January 8, 2024

Subject: Joint comments on OEHHA's First Public Review Draft Proposed Health-Protective Concentration for the Noncancer Effects of Hexavalent Chromium in Drinking Water

Technical Comments on OEHHA's Proposed Non-Cancer Health Protective Concentration for Hexavalent Chromium

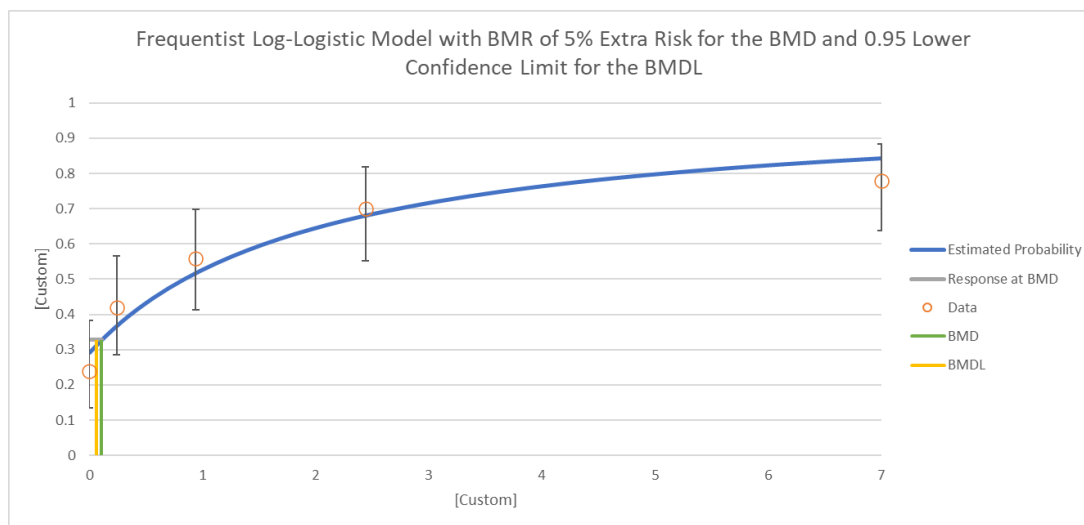
The first step in HPC derivation is determination of a POD. Even if one disregards the available evidence and assumes that liver effects in female rats is the critical effect and uses the doses reported in OEHHA (2023), modeling of liver inflammation results in a BMDL₅ of 0.065 mg/kg-day (see **Figure 1** below), identical to that reported in OEHHA (2023). However, the model results reveal a flaw in OEHHA's policy to use a default 5% benchmark response (BMR) instead of EPA's default 10% BMR for POD derivation. In this case, the BMDL₅ is more than 3-fold lower than the lowest non-zero dose of 0.24 mg/kg-day. This indicates uncertainty in the BMDL₅ value because it is below the range of empirical observation. Several other viable models resulted in BMDL₅ values ranging from 0.18 to 0.35 mg/kg-day; OEHHA could have selected one of these values. Alternatively, OEHHA could have used the default 10% BMR typically used by the USEPA (U.S. EPA 2012). Figure 1 also shows the high 24% background incidence of liver inflammation in unexposed female rats mentioned previously. Taken together, the available evidence warrants use of a different model or a 10% BMR in deriving the POD.
